DESIGN REVIEW REPORT AND DECISION

File Number: DSRFY2026 - 0004

Review Status: APPROVED AS CONDITIONED

The applicant, Erik Hagen, is requesting approval for the new construction of a 5,400 sq. ft. professional office building located at 6655 N Glenwood Street. The project proposes one new structure with associated parking, landscaping, and site improvements within the existing commercial business plaza.

Site location

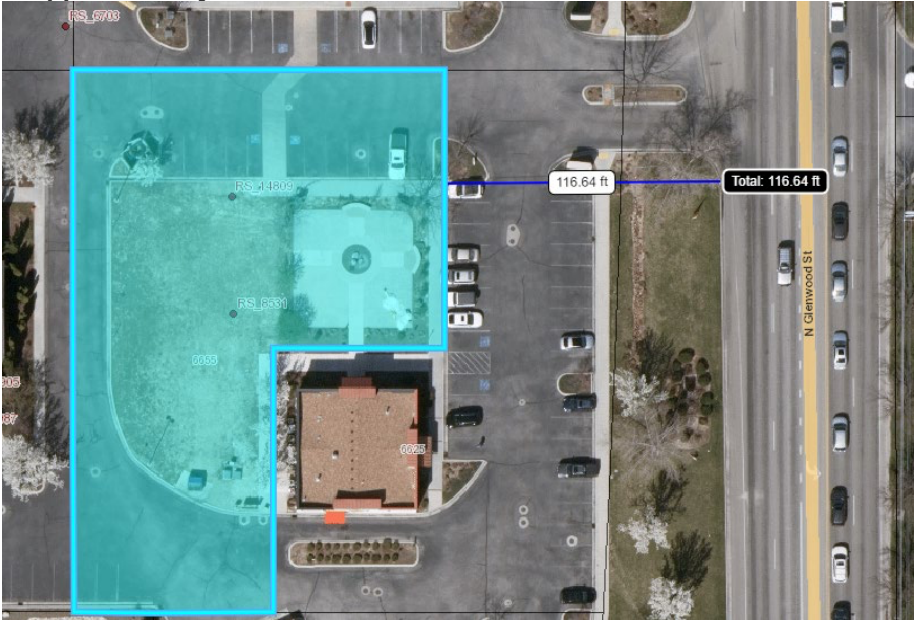
The project site is an interior parcel within the Hoke Subdivision No. 2 business plaza and does not directly front a public right-of-way. Access is provided from Glenwood Street via shared drive aisles serving adjacent commercial uses.

Although sidewalks exist along Glenwood Street, the parcel is not directly adjacent to the public sidewalk system. A parking lot located outside the site boundaries lies between the site and the sidewalk. Instead, the site relies on an internal pathway network that connects the business plaza to Glenwood Street. While the site benefits from a shared pedestrian pathway running through neighboring properties, there is no direct pedestrian connection from the proposed building to the public sidewalk. Additionally, the existing pedestrian pathway system does not provide a direct connection to the commercial buildings to the south, limiting overall internal circulation and walkability.

These conditions trigger consideration under GCC 8-4E-3 and 8-4E-7 related to public street connections and pedestrian accessibility. Given the Comprehensive Plan’s emphasis on multimodal connectivity within the Green Boulevard Corridor, improving the clarity and continuity of pedestrian routes would further align the development with community goals.

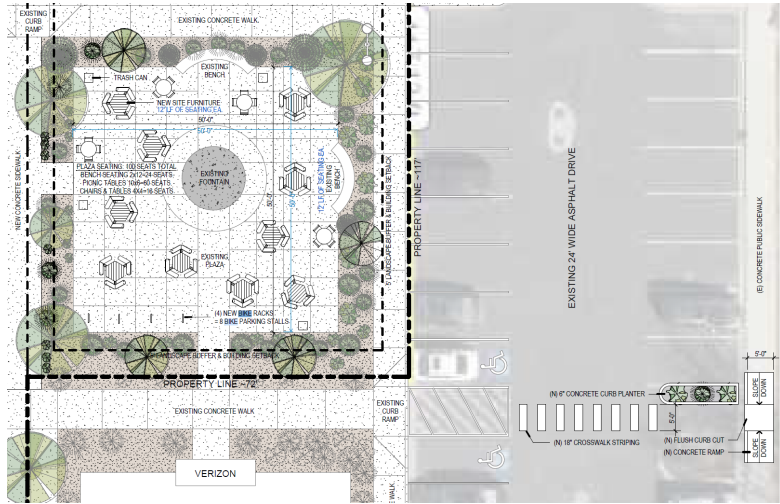
8-4C-4 Special Provisions for Specific Non residential Development	Compliant	<p>Based on resubmittals dated 01/10/2026</p> <p>Plaza Requirements:</p> <ol style="list-style-type: none"> 1. To qualify as a pedestrian plaza, an area should have: <ol style="list-style-type: none"> a. Pedestrian access (including handicapped access) into the plaza from the public right of way. b. Paved walking surfaces such as concrete, brick pavers, or other type of pavers on level, stepped, or gently sloping (less than 3 percent grade). c. One linear foot of seating per perimeter linear foot of the plaza. d. Security lighting on site or building mounted. e. A minimum size of five hundred (500) square feet with the shorter dimension of a plaza less than three (3) times the height of surrounding buildings. f. Buildings on plazas should promote and accommodate outdoor activity with balconies, arcades, terraces, decks, and courtyards for residents' and workers' use and interaction. g. Distributed trash containers around the plaza. h. Direct access to occupied indoor space. i. Located so that the build provides buffering from street noise when the location is on a major arterial.

<p>2. A pedestrian plaza is encouraged to have:</p> <p>a. Site furniture:</p> <ul style="list-style-type: none"> i. Seating may be on planters, rails, benches, retaining walls and other raised surfaces. ii. Cluster and movable seating for informal gathering and outside eating areas. iii. Locate seating for sun exposure, where views can be taken advantage of, and near to activity centers of a site such as at building entrances and at the intersection of walkways. <p>b. Artwork, or amenities such as fountains, kiosks:</p> <ul style="list-style-type: none"> i. Interactive art, sculpture, and fountains which people can touch and move. ii. Fountains for visual attraction, to screen traffic noise, and for cooling effects.
8-4C-5 Prohibitions	No compliance issues noted	There are no visible false fronts, prefabricated structures or prohibited materials proposed with this application.
